ADDENDUM NO. 1
March 18, 2024

NORTHGATE SEWER LIFT STATION EMERGENCY POWER IMPROVEMENTS

DETAILS

E2.1

1 SINGLE LINE DIAGRAM
SCALE: NTS

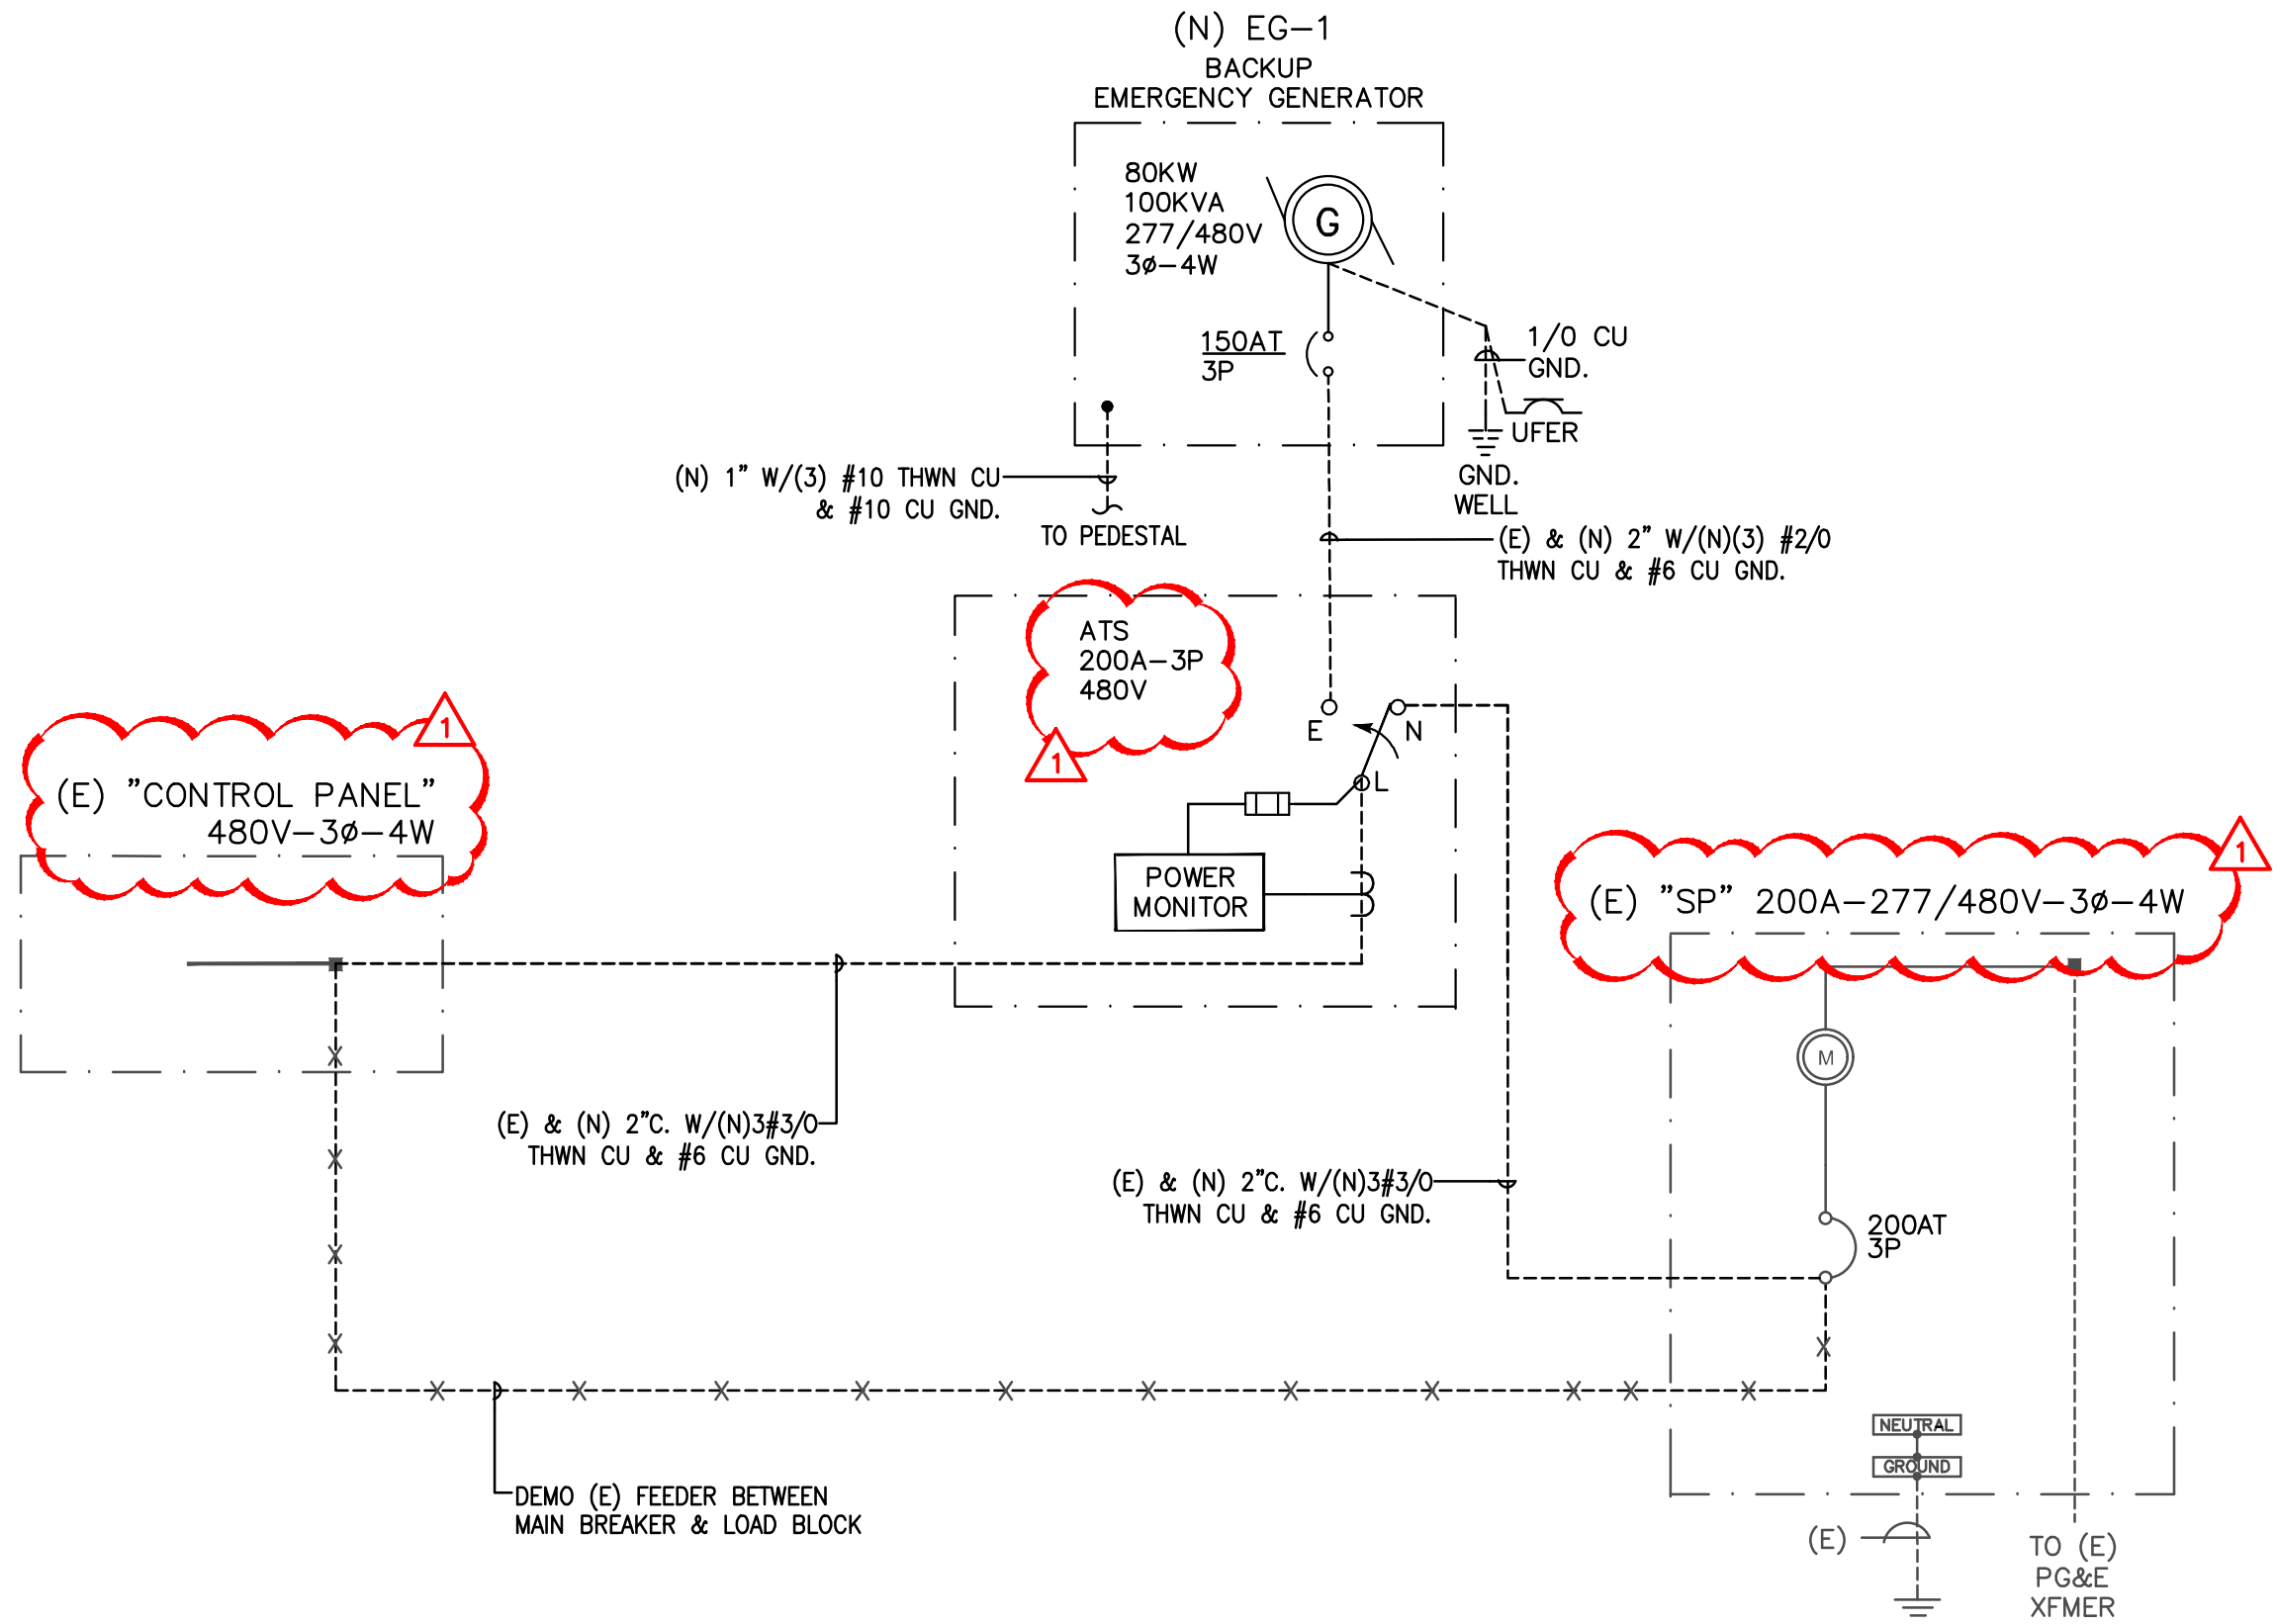
SHEET E2.1 OF PLANSET

Drawing E2.1 has updates to amperage and voltage shown in the single line diagram.
